MASTER DEVELOPMENT DRAINAGE PLAN & FINAL DRAINAGE REPORT

MONUMENT ACADEMY

Engineering Review

*EPC Planning & Community
Development Department*

**DETENTION POND C14
PLAN & DETAILS**

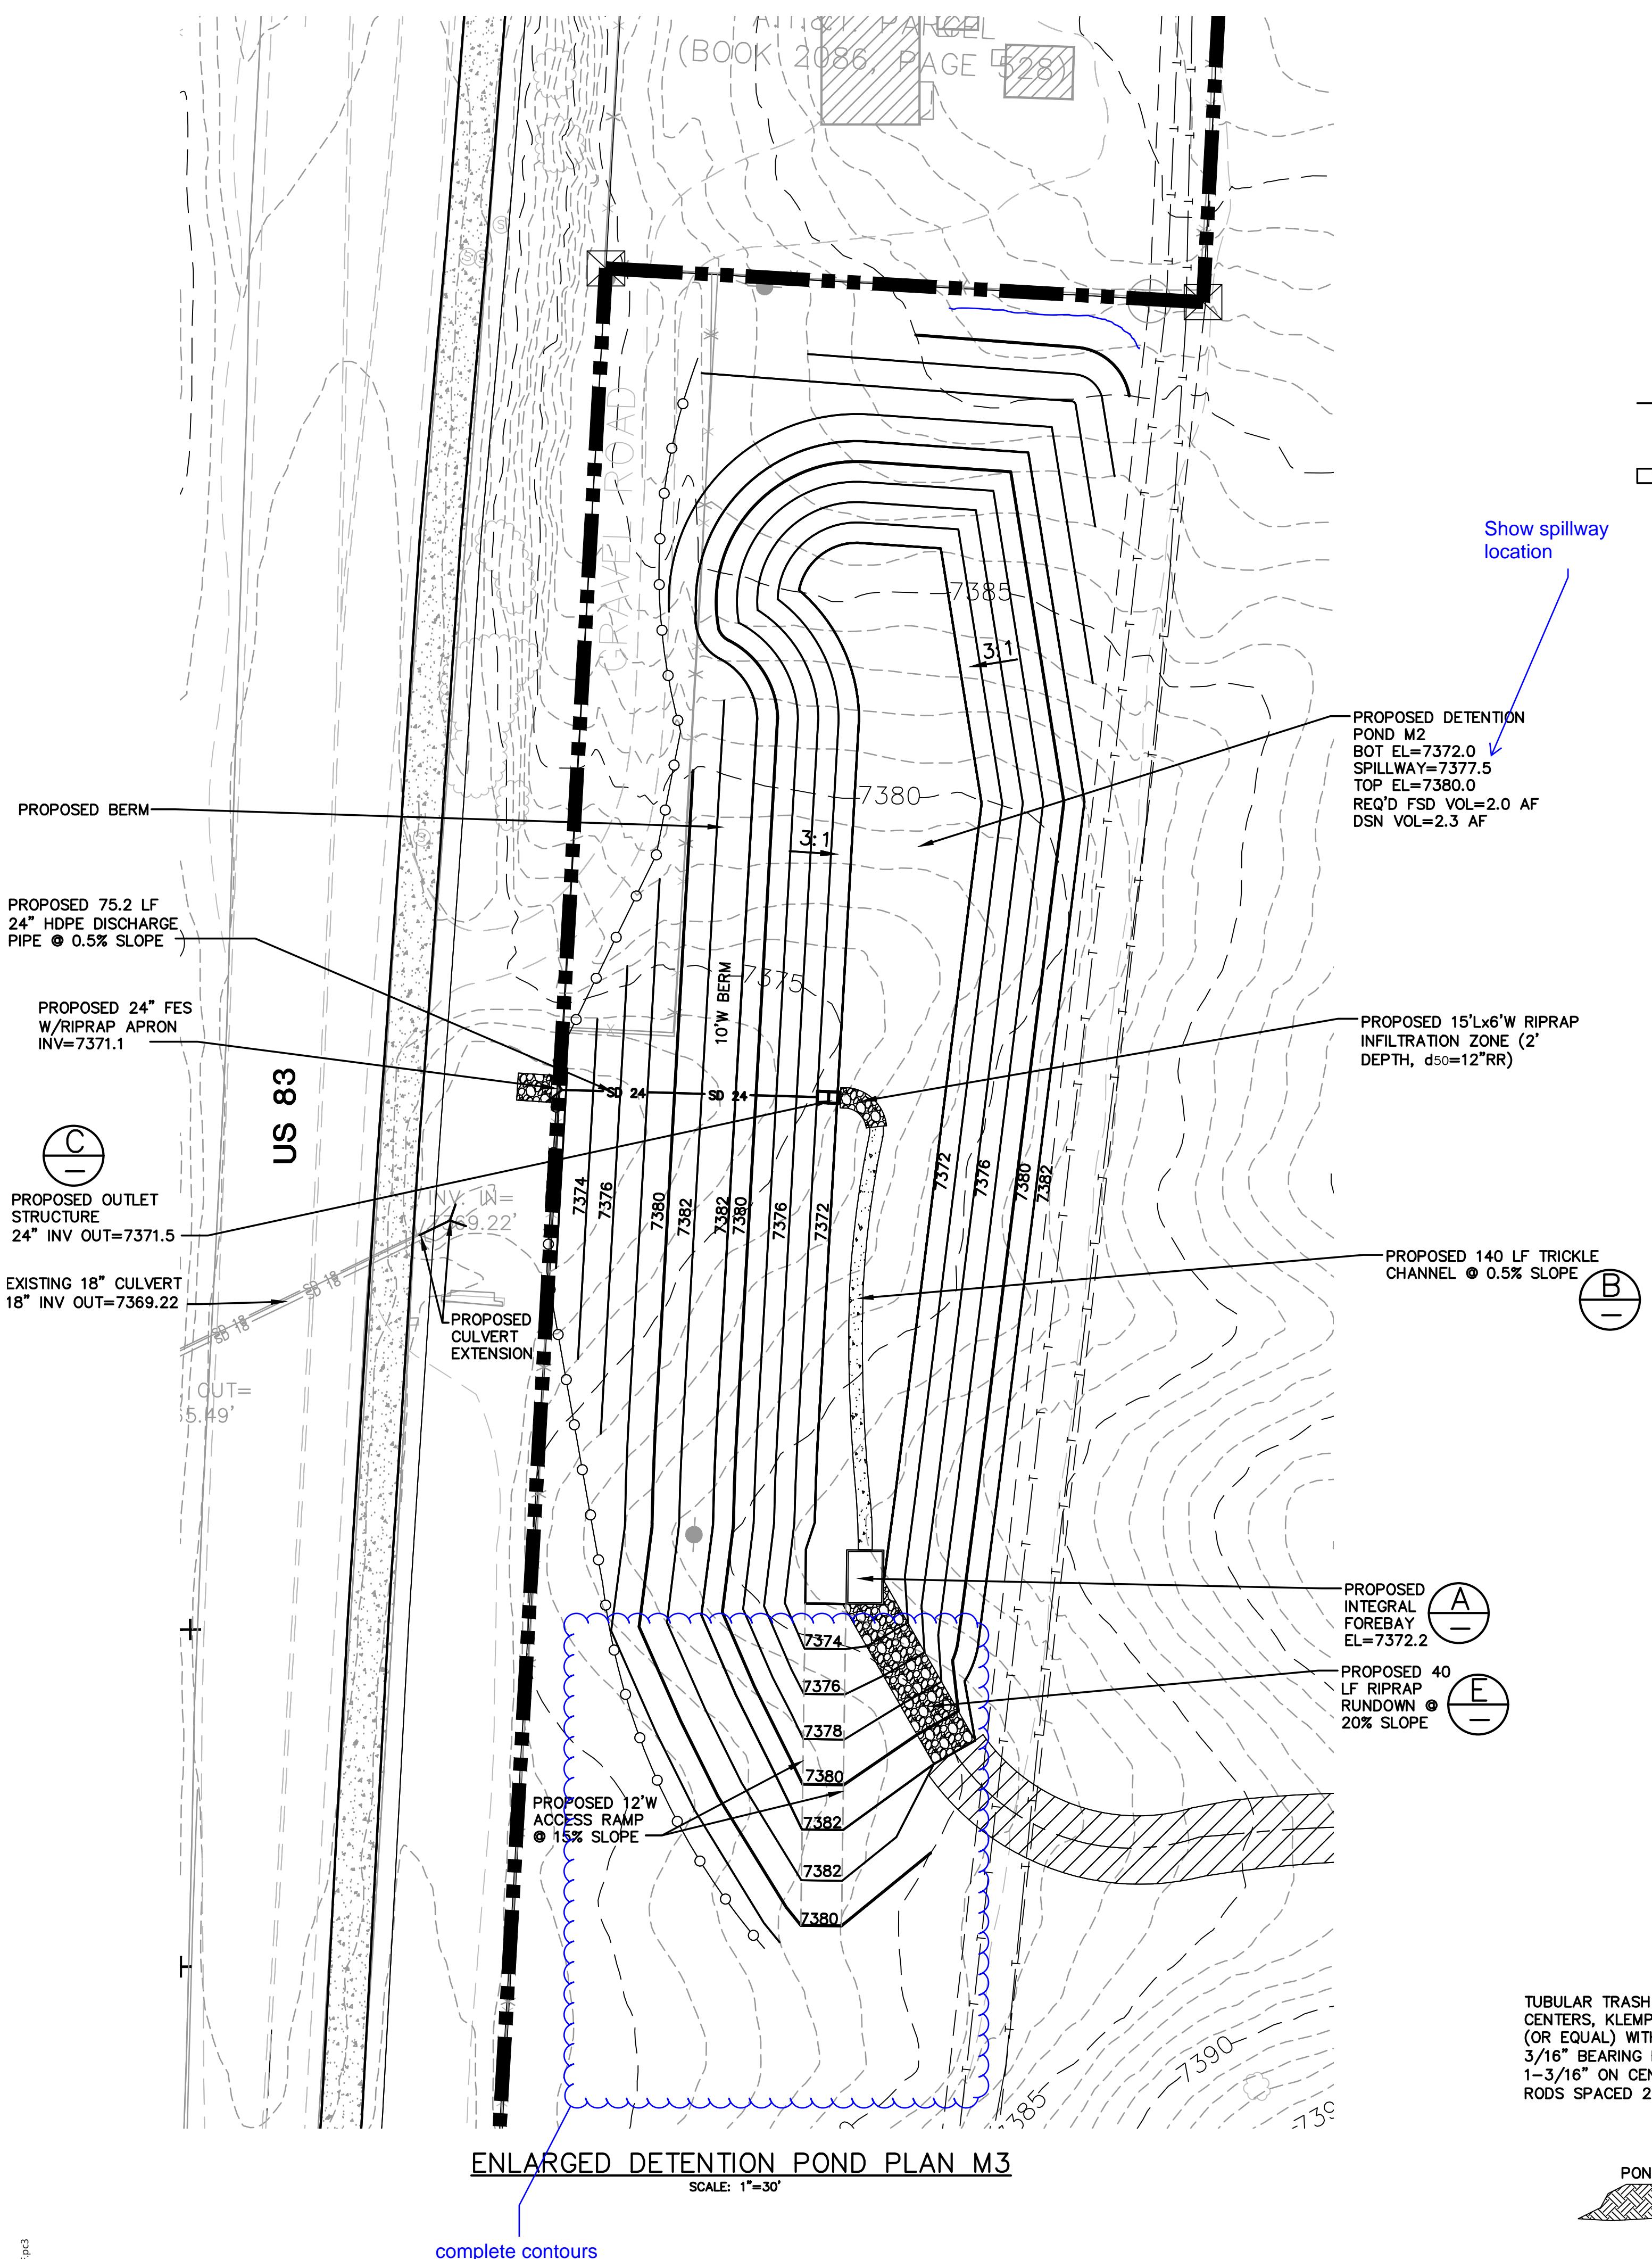
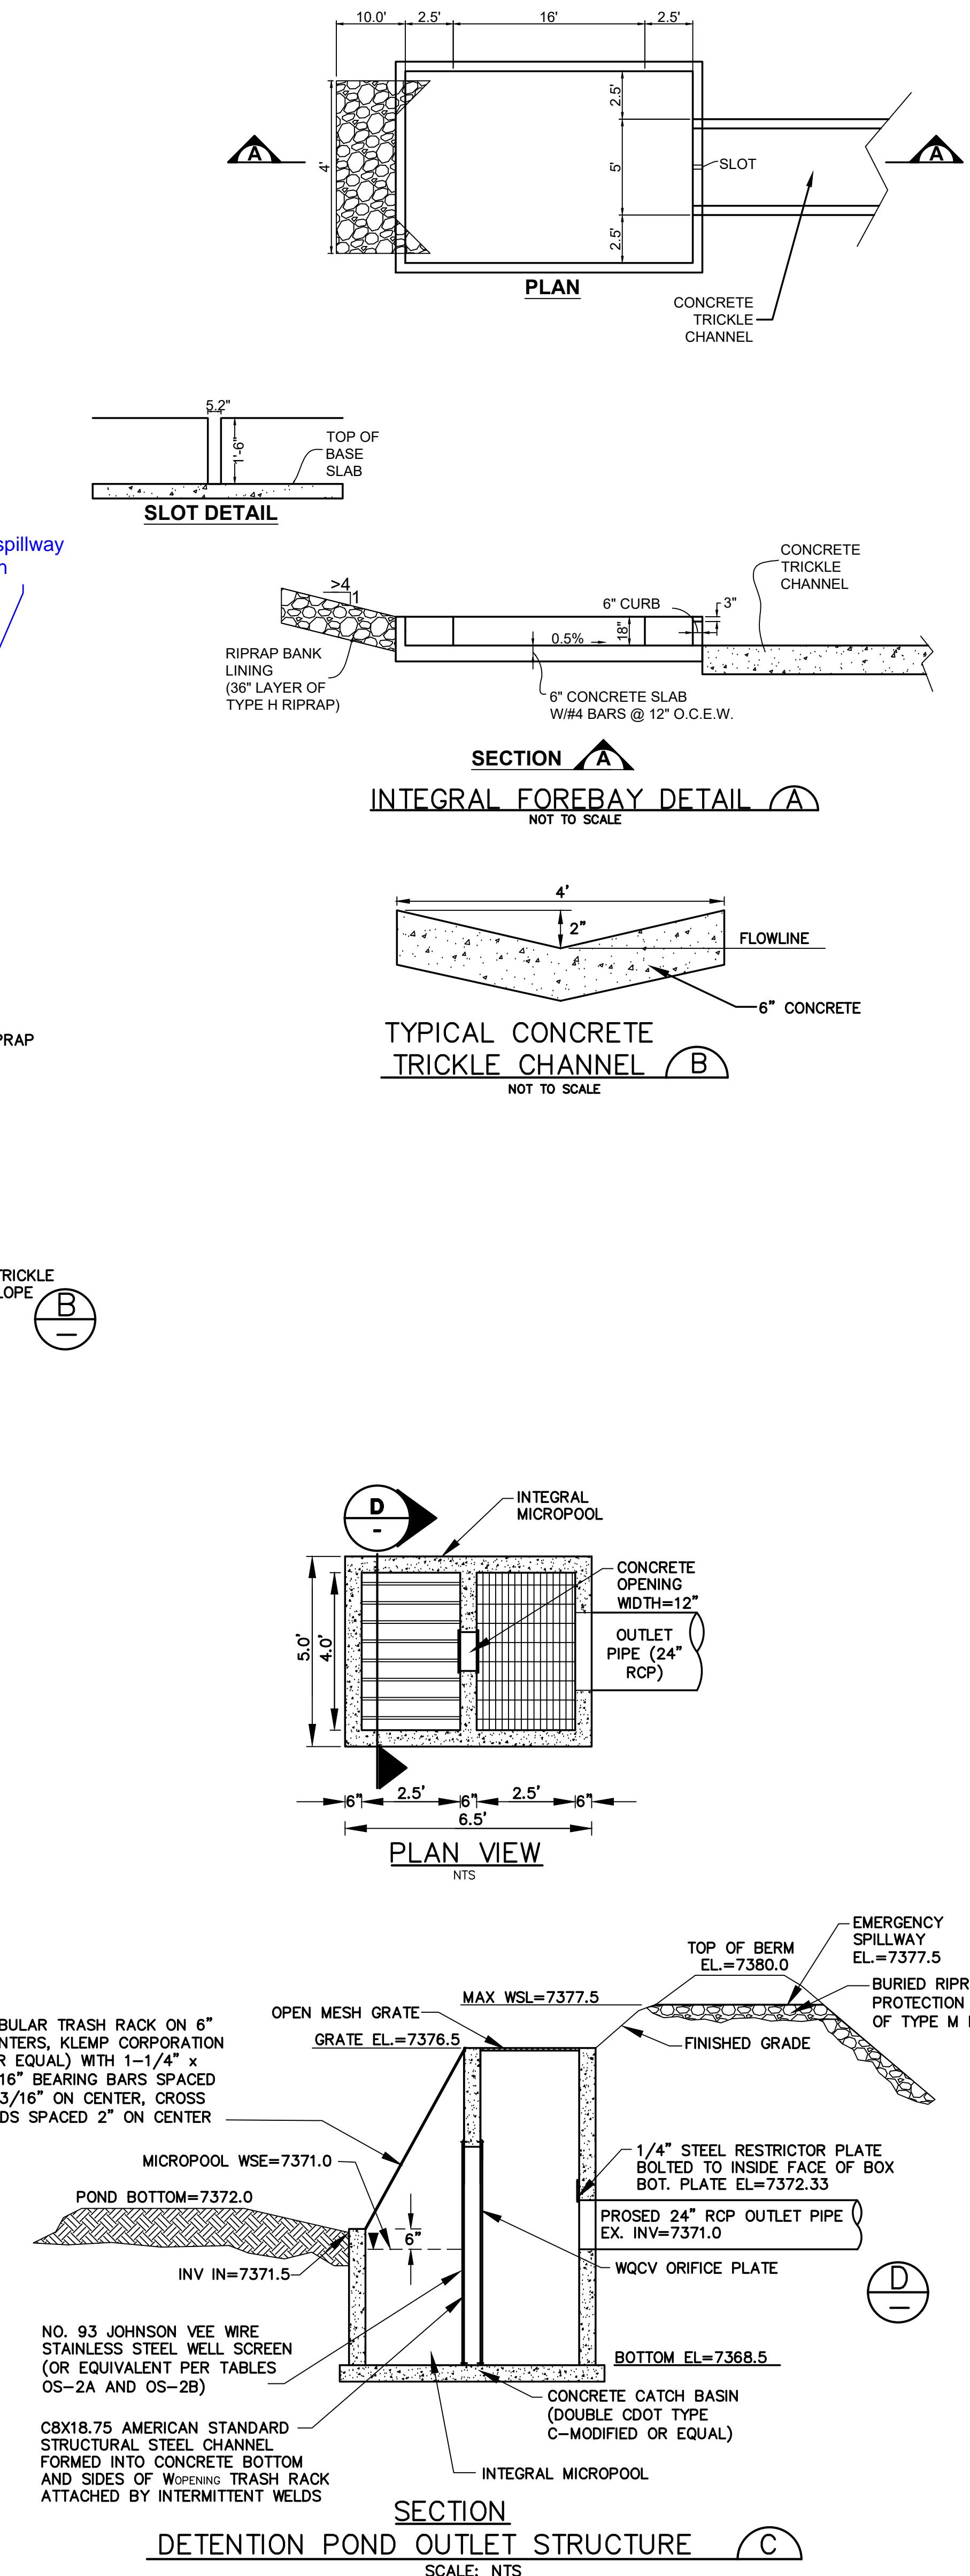
complete contours
